APPENDIX I

Agency Correspondence

Subject: SP 2506-83, Supplemental Early Notification review request

RE: SP 2506-83 ENM Vegetation Review

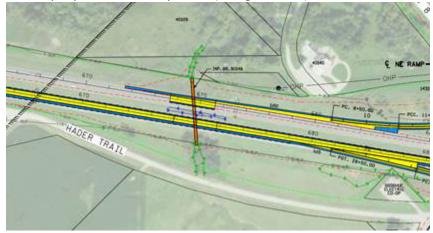
b. Unnamed watercourse (to Belle Creek), no work proposed (STA 603-604).

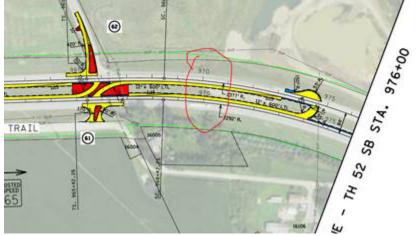
c. Belle Creek, proposed to be replaced (bridge 91048)

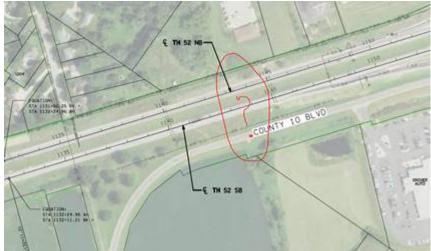
f. Unnamed Watercouse (no work planned) Bridge 91047
